ADDENDUM

NO. 3

PROJECT NAME: Humble ISD Creekwood and Riverwood Middle School Additions and Renovations

ADDENDUM DATE: Tuesday, April 29th, 2025

9 INTERIOR ELEVATION - GYMNASIUM
1/8" = 1'-0"

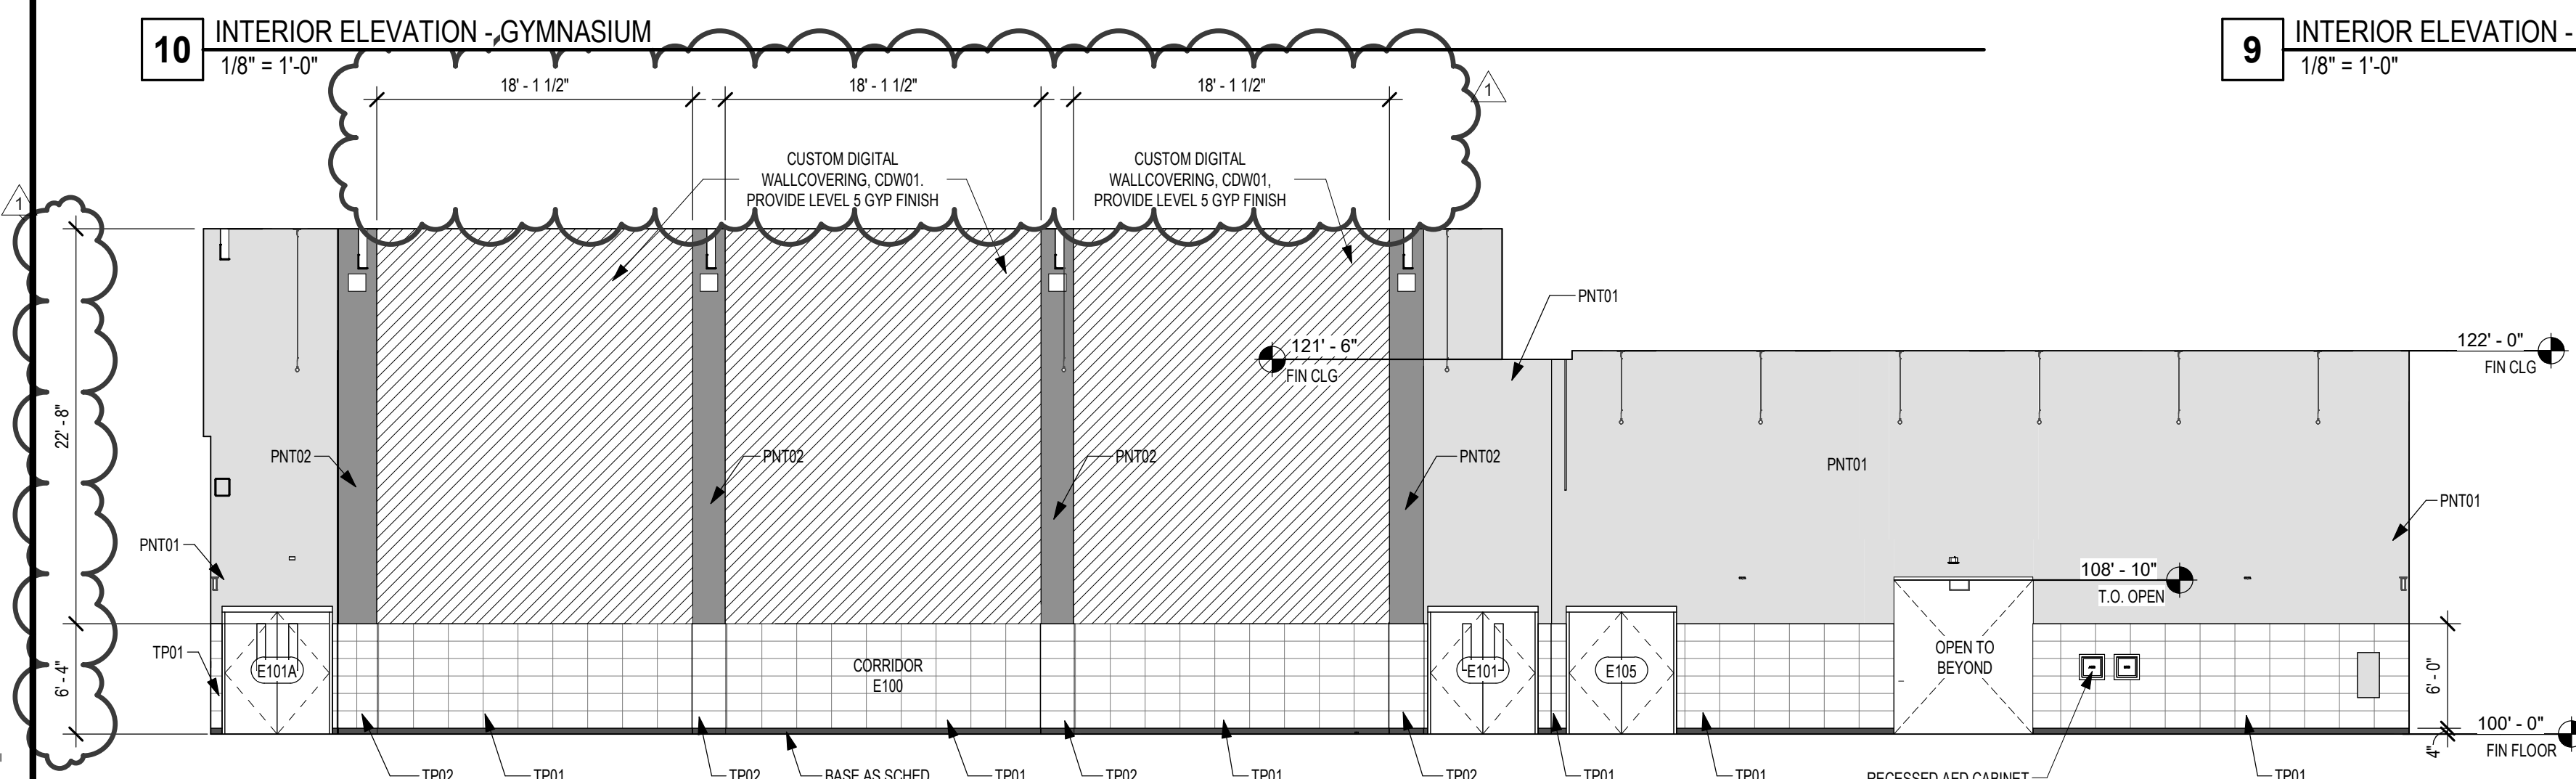
- 7/A4.18 – Dimensions and notes added/revised to clarify graphics scope.
- 9/A4.18 – Dimensions and notes added/revised to clarify graphics scope.

FINISH PLAN - SECTION A, F

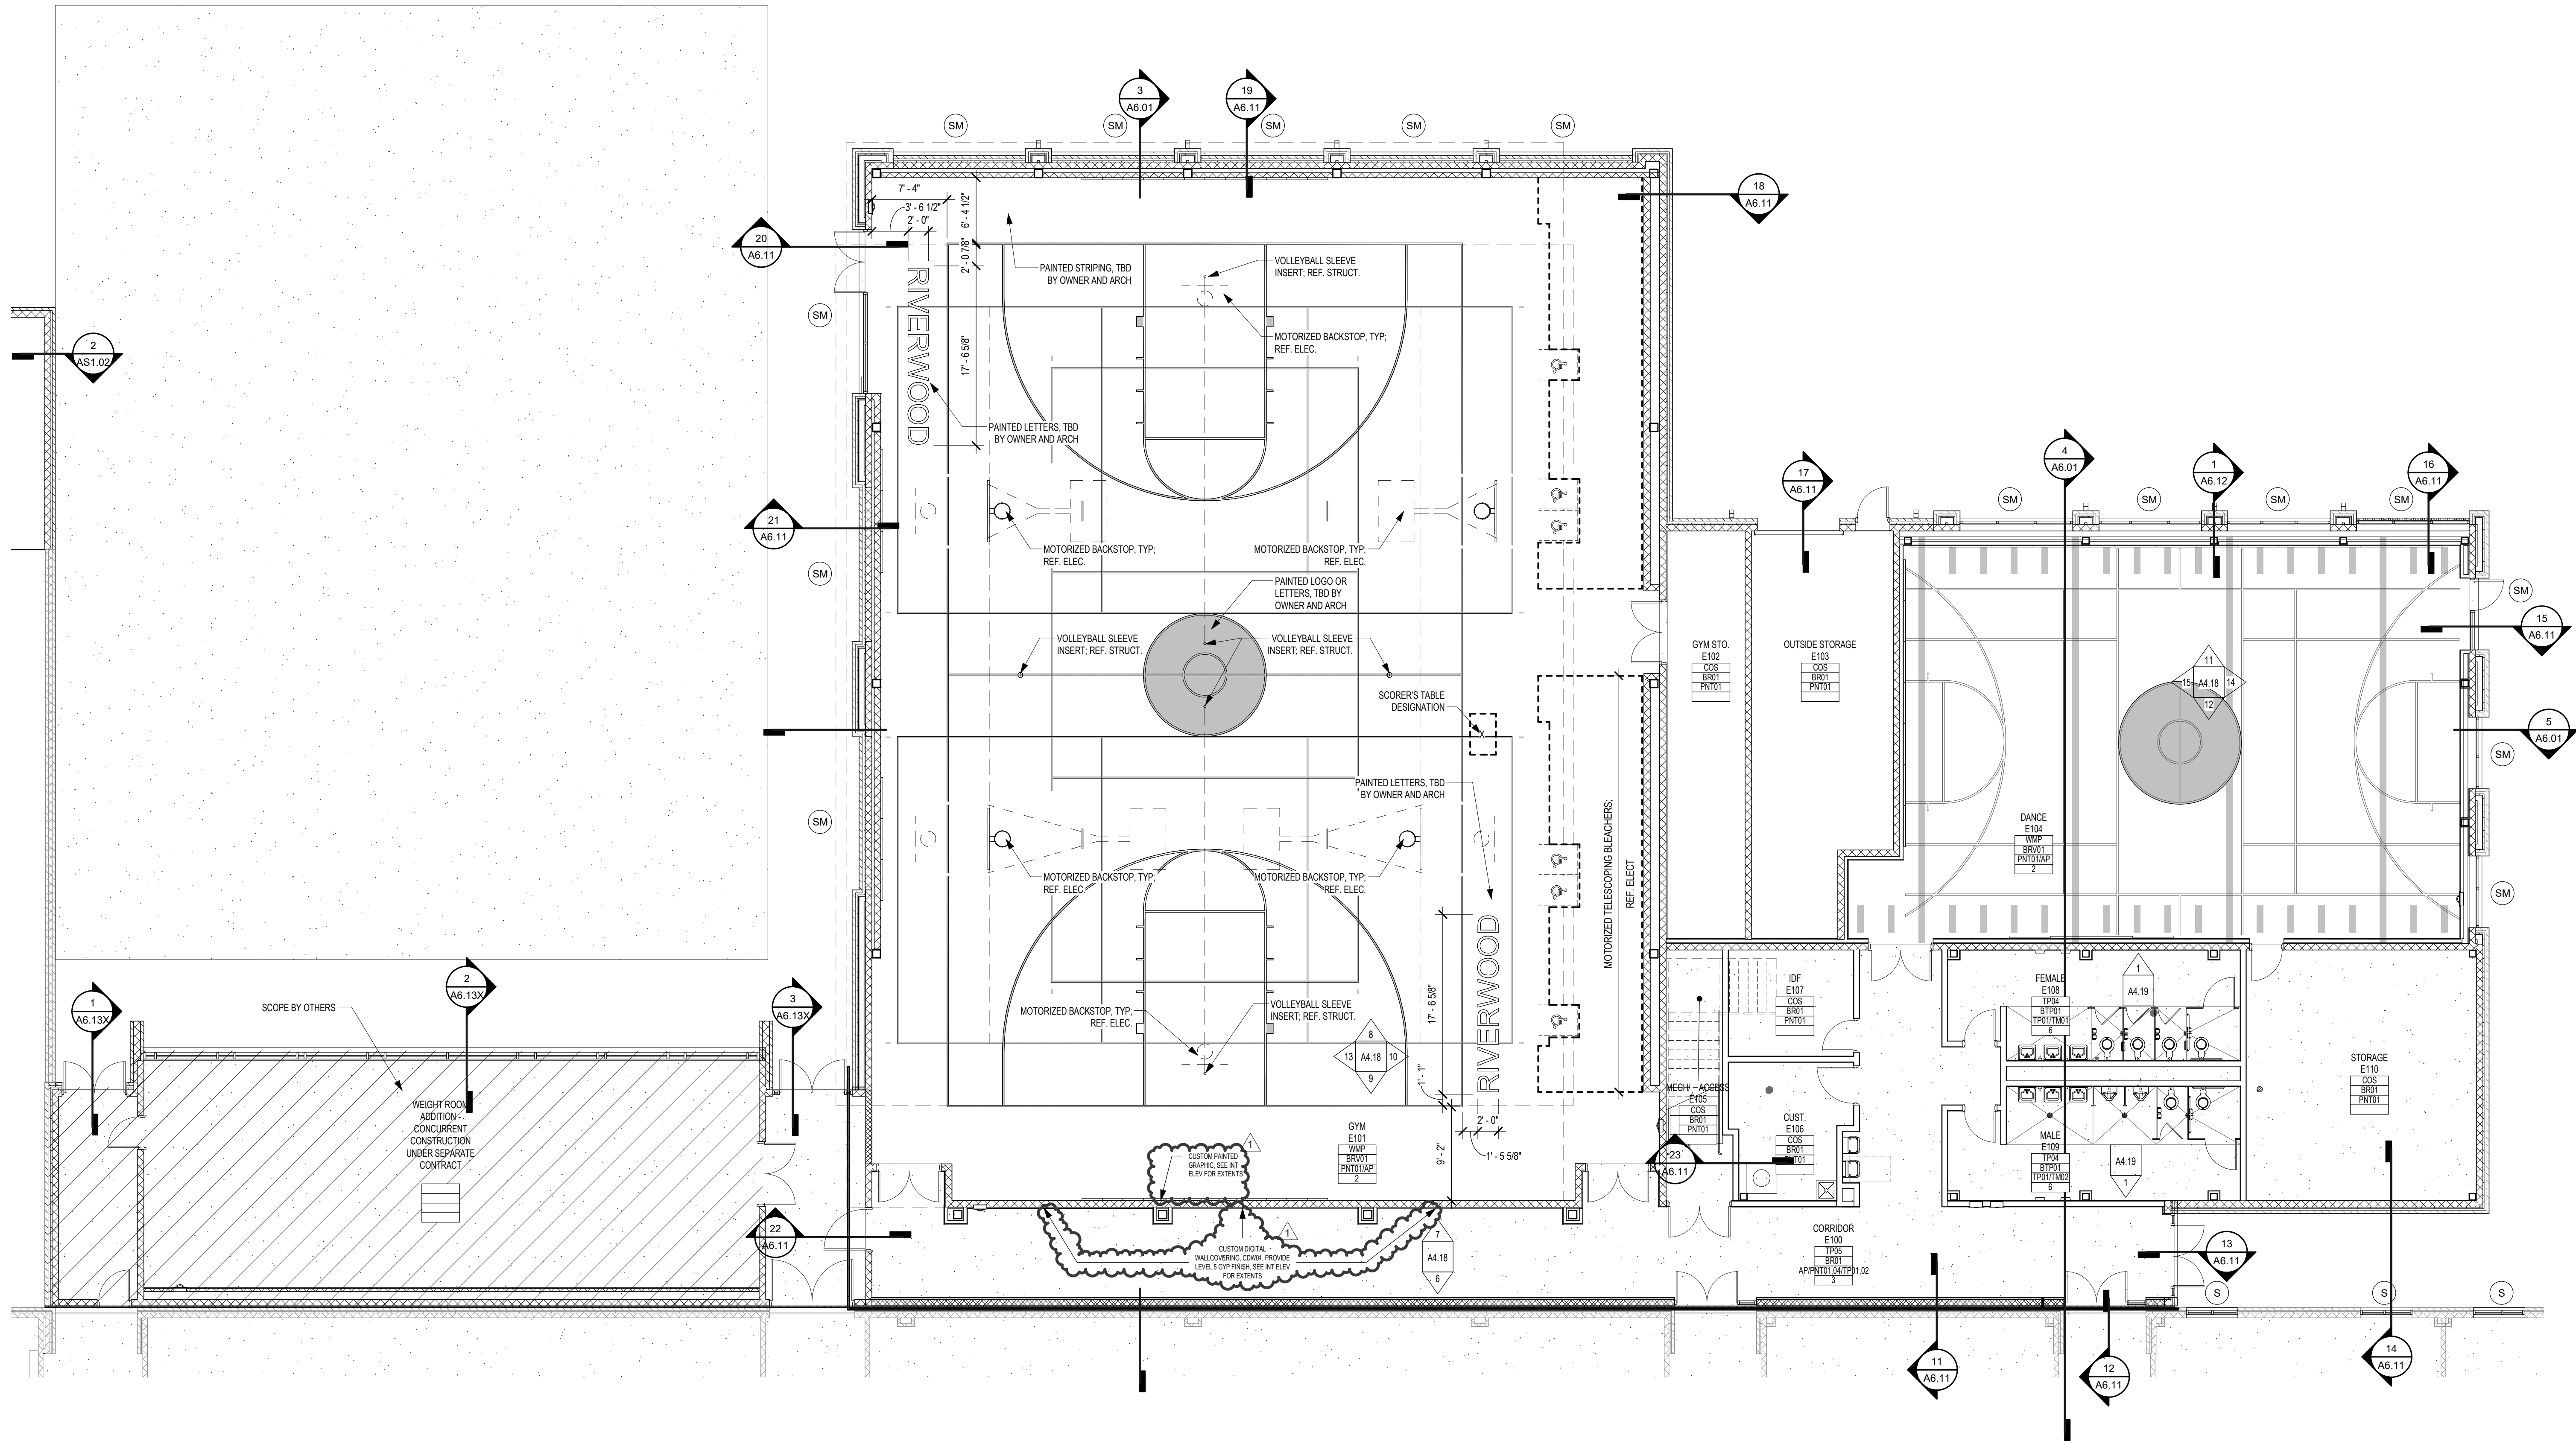
- Note revised in Lobby A132 to clarify graphics.
- Removed legend regarding alternates.

9 INTERIOR ELEVATION - GYM
1/8" = 1'-0"

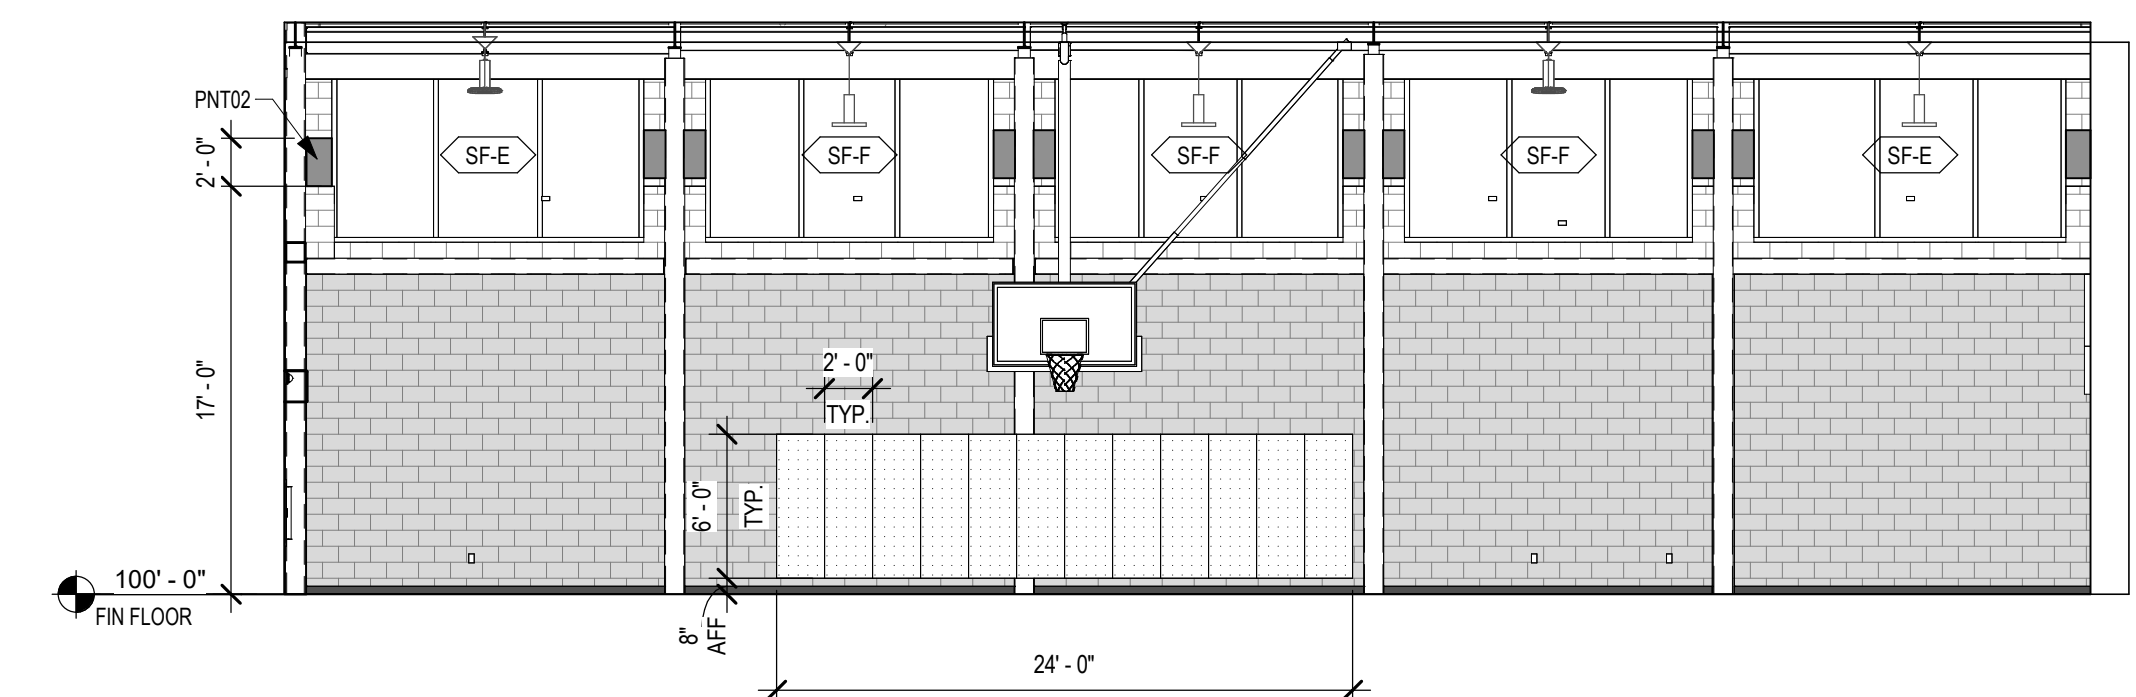
- 7/A4.18 – Dimensions and notes added/revised to clarify graphics scope.
- 9/A4.18 – Dimensions and notes added/revised to clarify graphics scope.

ELECTRICAL POWER FLOOR PLAN - SECTION A

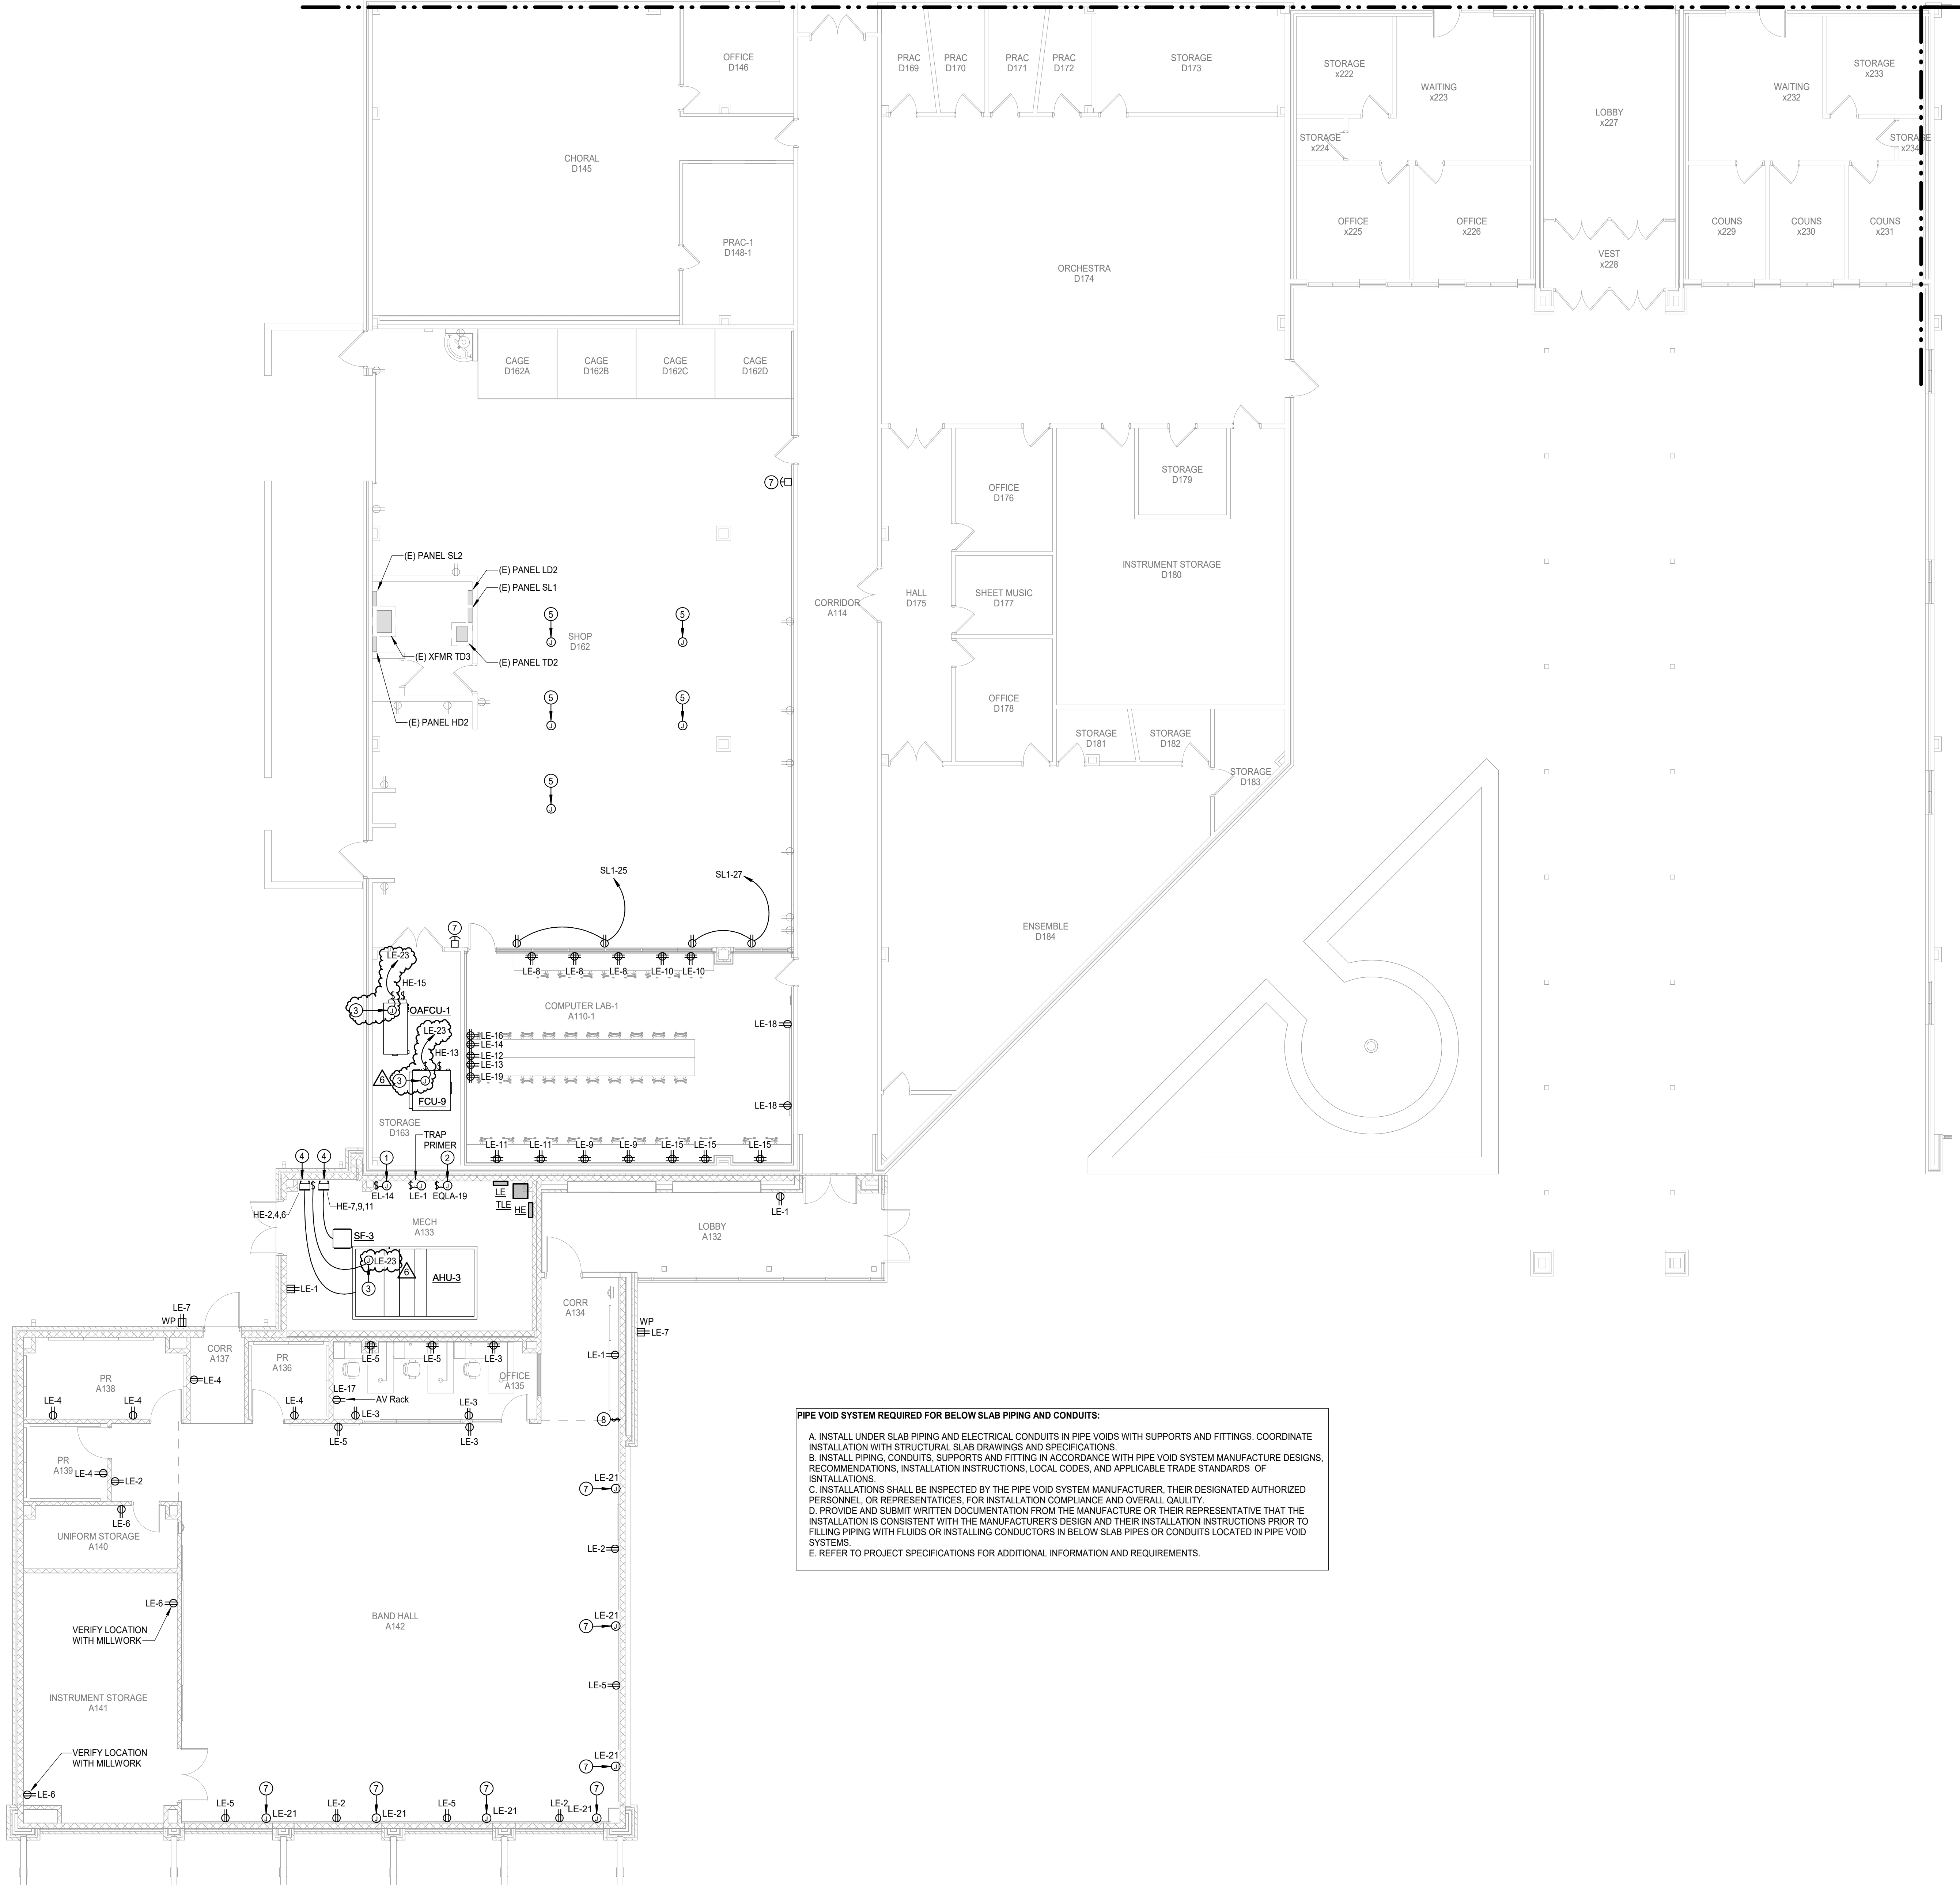
2. E3.11 – ELECTRICAL POWER FLOOR PLAN – SECTION A
 - a. Add 120v branch circuitry to AHU-3, OAFUCU-1, and FCU-9 for air purification.
 - b. Replace sheet in its entirety.
